Author:	MRM (7/2017)		
Well Name	Wish Federal	Well No.	#1
Field	Teas Bone Spring	API#:	30-025-26241
County	Lea	Prop #:	
State	New Mexico	Zone:	Bone Spring
Spud Date	2/17/1979		1980 FNL & 1650 FEL
GL	3623'		Sec 27 T20S R33E
KB	3644'

## **Conditions of Approval**

# COG Operating, LLC Wish – 01, API 3002526241 T20S-R33E, Sec 27, 1980FNL & 1650FEL February 7, 2018

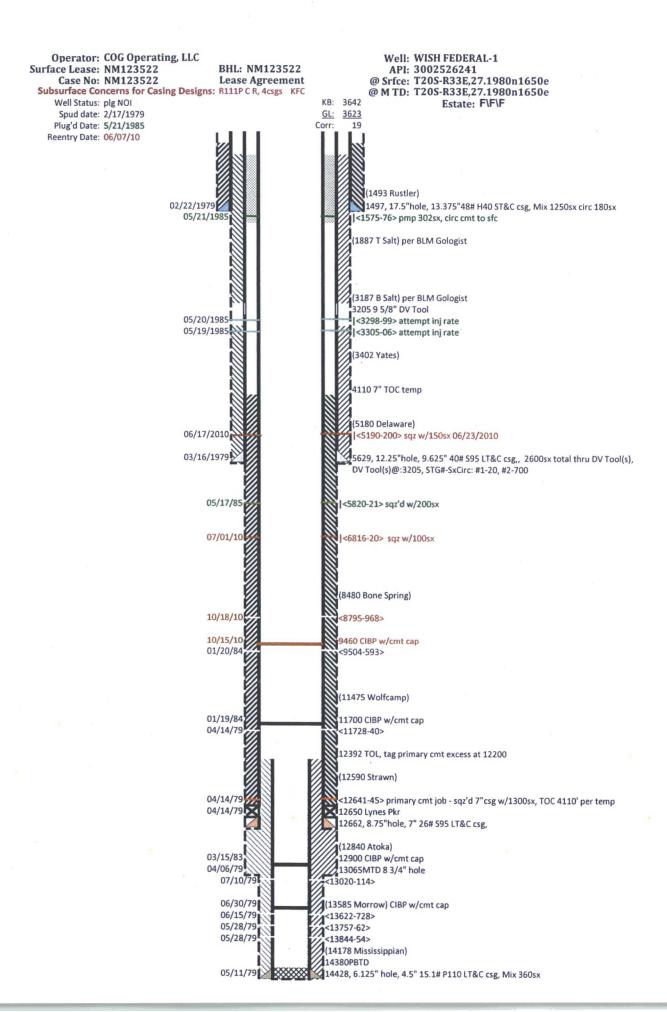
- 18. Remove plugs and tag the cmt cap on the 13585' CIBP.
- 19. Set a min 25sx balanced "H" cmt plug on the 13585' CIBP. WOC, and tag the plug with tbg at 13260 or above covering the 13585' Morrow formation top.

- 20. Set a CIBP within 100' of the top Atoka perf of 13020'.
- 21. Set a min 40sx balanced "H" cmt plug on the CIBP above the top Atoka perf of 13020'. TULE 12392 WOC, and tag the plug with tbg at 12500' or above covering the 12840' Atoka formation top, and the 7" shoe at 12662 and the Strawn formation top at 12590'.

- 22. Set a CIBP within 100' of the top Wolfcamp perf of 11728'.
- 23. Set a min 65sx balanced "H" cmt plug on the CIBP above the top Wolfcamp perf of 11728'. WOC, and tag the plug with tbg at 11410' or above covering the 11475' Wolfcamp formation top.

- 24. Set a CIBP within 100' of the Bone Spring perf of 9504'. Dump bail a 35' cmt cap on the CIBP.
- 25. Set a CIBP within 100' of the top Bone Spring perf of 8795'.

- 26. Set a min 75sx balanced "H" cmt plug on the CIBP above the top Bone Spring perf of 8795'. WOC, and tag the plug with tbg at 8420' or above covering the 8480' Bone 50 Holes 6816-6820 Spring formation top.

- 27. Pressure test the casing to 500psig after tagging the Bone Spring cmt plug.
- WOC, and 28. Set a min 25sx balanced "C" cmt plug across the 9 5/8" csg shoe from 5700. tag the plug with tbg at 5540' or above.

- A. Run a CBL 3300' to surface under 0psig and verify cement coverage in the 7" and 9 5/8" csg annulus. Set a 230sx balanced "C" cmt plug from 3250'. WOC, and tag the plug with tbg at 1830' or above.

- B. Perforate 7" csg at 3250' below the Base of Salt and at 1800' above the Top of Salt. Set a Pkr below between the perfs and establish circulation from 3250' to 1800' through the 7" and 9 5/8" csg annulus. Set a CICR at 1875'. Mix and suicide sqz a 400sx slurry into the annulus leaving 53bbls (1375') cmt in the 7" and 41bbls (1450') cmt in the annulus. Sting out of the retainer and set a 13sx cmt plug on the CICR. WOC, and tag the plug with tbg at 1800' or above.
- 30. Set a min 30sx balanced "C" cmt plug across the 13 3/8" csg shoe from 1600'. WOC, and tag the plug with tbg at 1430' or above.
- 31. Perf at 60' or below. Establish circulation through the 7" x 9 5/8" annulus. Fill with (±20sx) balanced "C" cmt plug and verify the 7" x 9 5/8" annulus and 13 3/8" csg from 60' cemented to surface.
